IMPORTANT SAFETY RECALL – RESPOND IMMEDIATELY
This notice applies to your vehicles, VIN list accompanies this letter.
NHTSA Recall No. 19V195 / Mertz ID M18-098

Mertz Manufacturing, Inc.
Plastic Fitting Recall M18-098
Notice, Page Three
March 29, 2019

Figure 1: Non-DOT Approved Tee

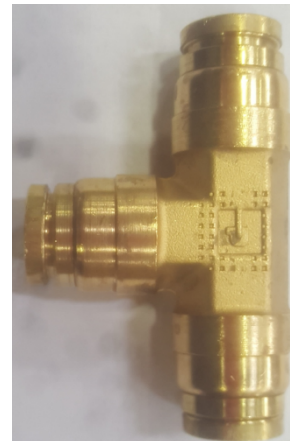
The 3-way, push-to-connect, black plastic tees (Figure 1) may have been incorrectly installed in some air brake circuits instead of the brass fittings (Figure 2). These plastic tees are approved in auxiliary circuits that are protected by a pressure protection valve.

If a plastic fitting is installed in the blue line and fails, loss of service brakes will occur, increasing the risk of a crash. Only the emergency braking system is available. If the plastic fitting is installed in the red line and fails, the emergency brakes activate, causing the trailer to stop unexpectedly and increasing the risk of a crash.

- 1) Inspect all of the trailers listed on the included VIN list. Mertz will provide replacement brass tees and reimburse for the labor, up to 30 minutes (one half hour), required to replace the tee(s) in the braking circuit. If you find any of the black plastic tees shown in Figure 1 used on your affected trailers, please contact Mertz Manufacturing, Inc. (below).
